# PRODUCT CHANGE NOTIFICATION

### Bourns® Model 39 Series 13 mm Single-Turn Panel Control with Switch Option

#### *Substrate Material Change*

SC2411

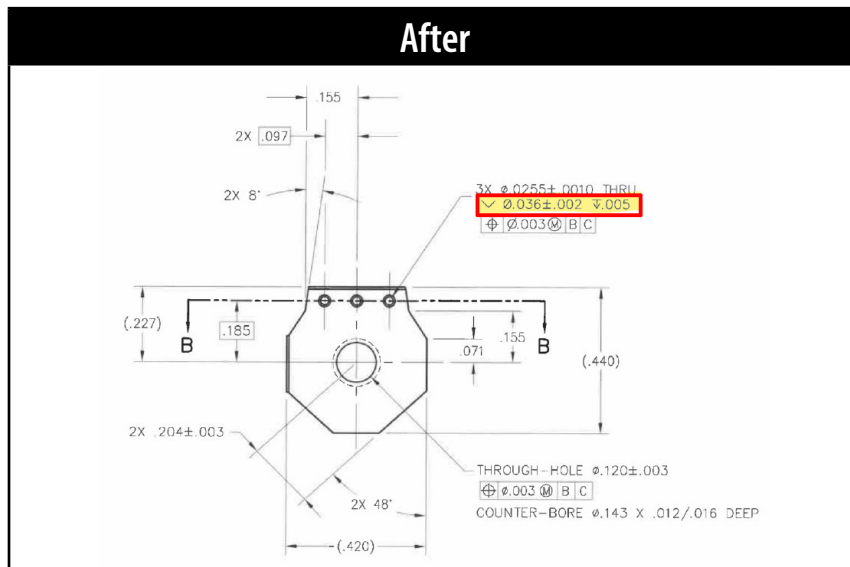
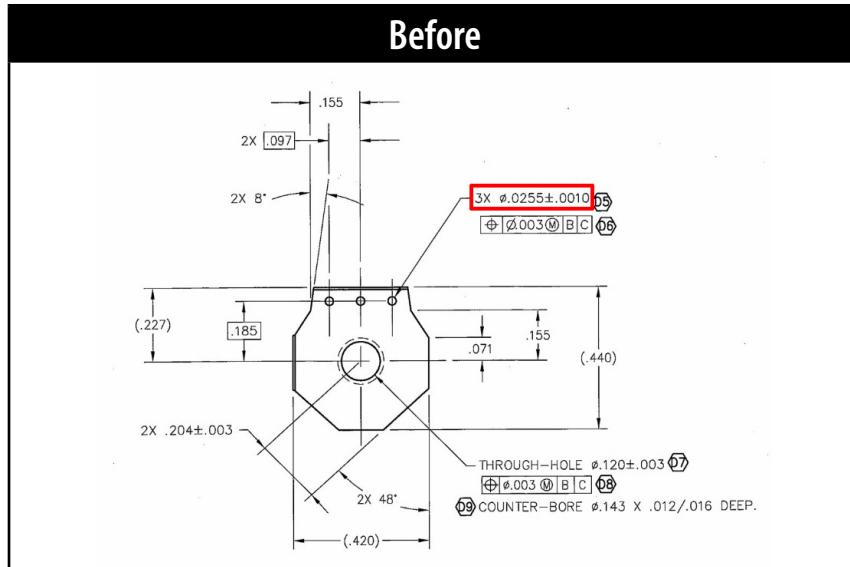
Riverside, California – May 7, 2024 – In the spirit of continuous improvement, effective March 1, 2025, Bourns will change the ink depth of the substrate material from .003 inch to .005 inch for the [Model 39 Series 13 mm Single-Turn Panel Control with Switch Option](#). A list of affected part numbers is included below.

There is no change to the form, fit, function or quality of the affected part numbers. The reliability of the affected part numbers will improve due to better flow of resistive ink after the ink depth is reduced. Traceability will be maintained through lot code and date code.
